Title: Advisory Committee on Reactor Safeguards
Digital Instrumentation and Controls

NRC presentation on overview and review
framework: Instrumentation and Controls
for Non-Light-Water Reactor Reviews -
Jordan Hoellman and Joe Ashcraft 16

Design Review Guide (DRG): Instrumentation and Controls for Non-Light Water Reactor (Non-LWR) Reviews

Advisory Committee on Reactor Safeguards
Subcommittee Meeting

Safety-focused

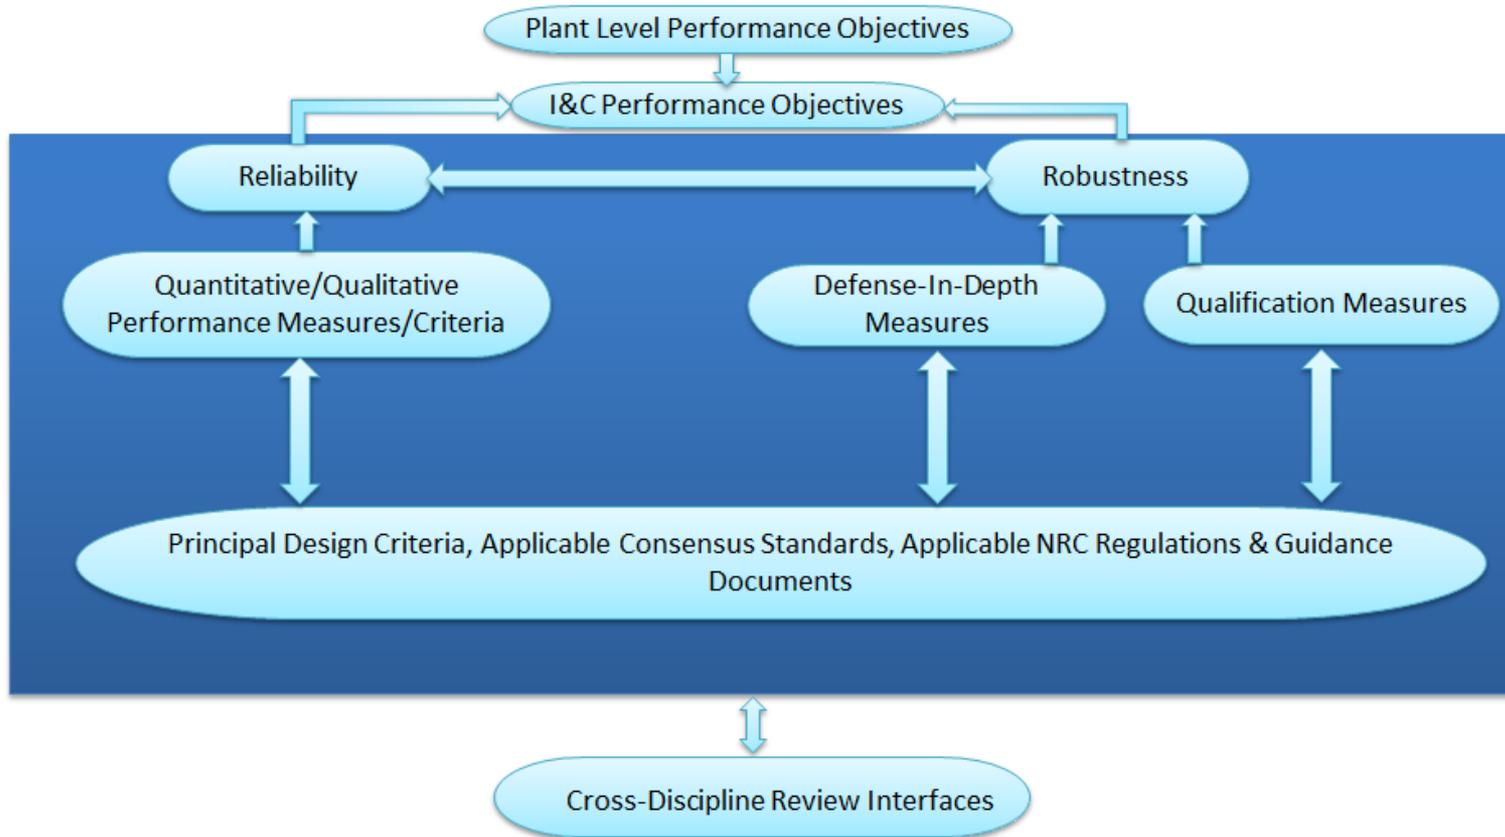
12 So, if you look, the blue box area, that's
13 what the I&C staff will be reviewing. So, we're
14 looking for demonstration that the I&C performance
15 objectives have been met in the terms of -- on the
16 left side -- reliability of the I&C design, which is
17 the probability that a system or component will meet
18 its minimum performance requirements under all plant
19 conditions. Quantitative and qualitative performance
20 measures and criterias are used in support of this
21 portion of the assessment.

15 The I&C reviewer should also interface --
16 and that's the bottom bubble below the blue box --
17 with other technical disciplines to verify that any
18 cross-discipline area issues are adequately identified
19 and resolved.
